TEM Server 7.5

Service Release Notes

Revision 7.5.1 • 14-Sep-20

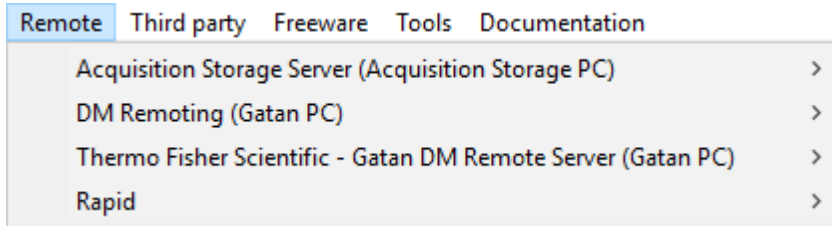
- Applications Master Installer:
The *FEI* menu item is renamed to *Remote*
